**GOVERNMENT OF THE DISTRICT OF COLUMBIA  
ADVISORY NEIGHBORHOOD COMMISSION 3D  
PO Box 40486, Palisades Station  
Washington, DC 20016**

**Testimony of Alma H. Gates on Behalf of ANC 3D  
BZA Application No. 18983  
January 25, 2016**

**A NEW ACCESSORY GARAGE**

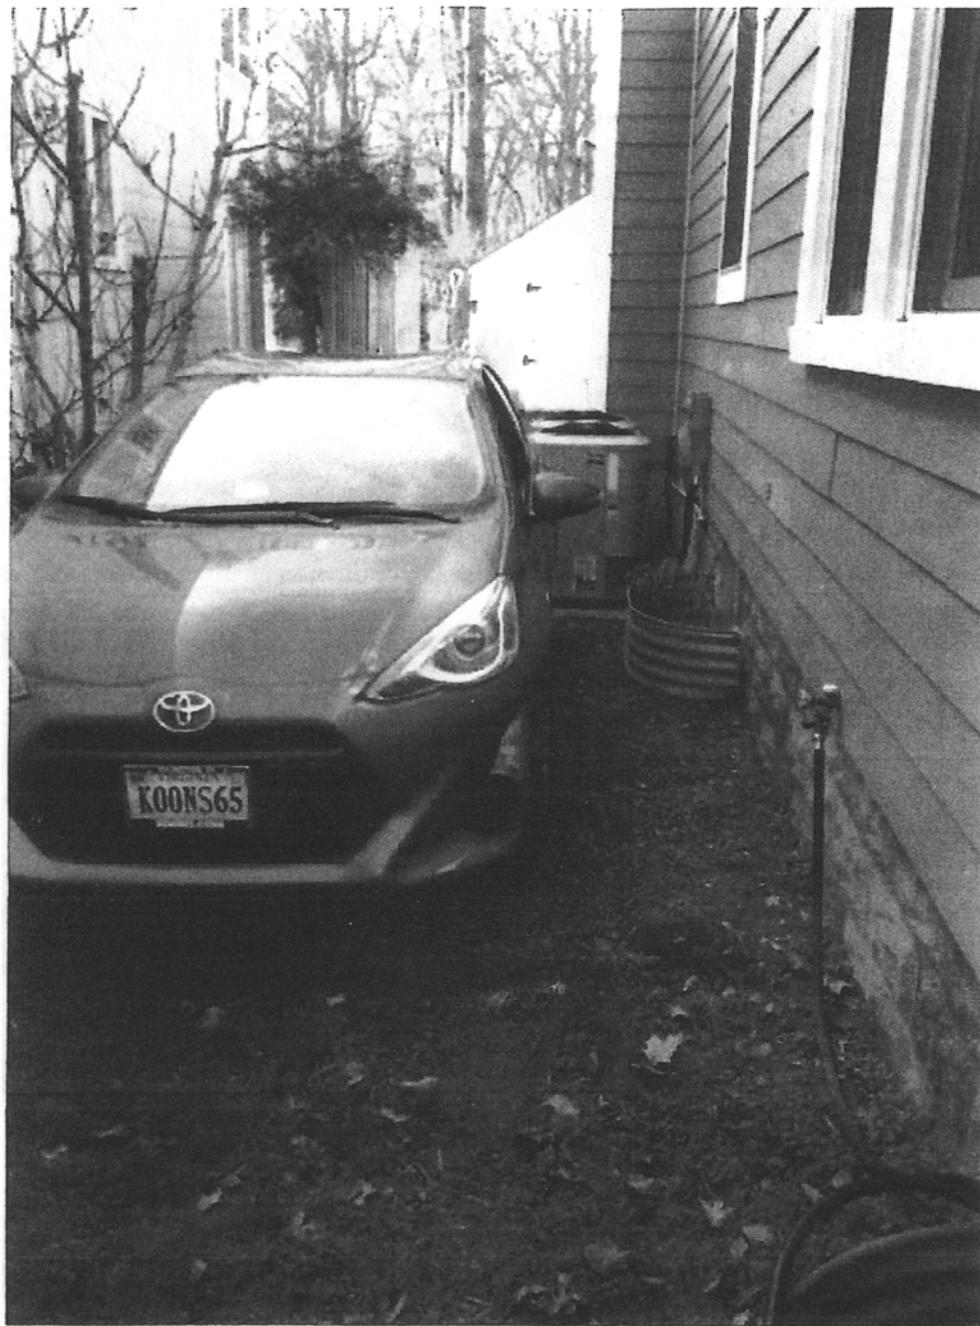
In terms of burden of proof, the Applicant has failed to make its case. Rather, the Applicant has succeeded in confusing OP as well as neighbors who submitted form letters which refer to a replacement shed. The proposed structure increases lot occupancy by 9 percent and would exceed total lot occupancy by 10 percent. This is not a replacement, it is a much larger structure which the current drawings indicate may be used as an accessory dwelling unit.

It should be noted that the required off-street parking space may not be properly provided and may not meet the requirements of § 2116.4(b). ANC 3D is including photos which show that the owner’s van is parked in front of, rather than behind, the façade of the home and just behind the public sidewalk. Driveway pavers do

not extend back far enough to accommodate the required parking space as the driveway is blocked by HVAC units, a window well and the area designated to store the owner's Supercans.

Will this structure visually intrude upon the character, scale and pattern of houses along the subject street frontage? Yes, not only would it intrude upon the character and scale of the surrounding neighborhood, it would be taller and considerably wider than it is currently. It will be very visible from the trolley right of way which has been proposed by the community for reuse as a bike path.

The Application, if approved, would be precedent setting. In the lot diagram submitted of surrounding homes on Sherier Place, there is no other home with a free standing rear accessory structure or a structure which shares a lot line with the trolley right of way.

ANC 3D voted unanimously 7-0-0 to support a special exception from § 223 for construction of a new accessory garage structure provided the footprint of the existing accessory garage structure does not change or increase, and height does not exceed 15 ft; ANC 3D supports granting the Special Exception from § 223 provided lot occupancy at Lot 85 in Square 1415 does not exceed the current lot occupancy or 41 percent; and, ANC 3D supports granting the Special Exception from § 223 provided one off-street parking space is provided in accordance with the requirements of § 2116.4(b).
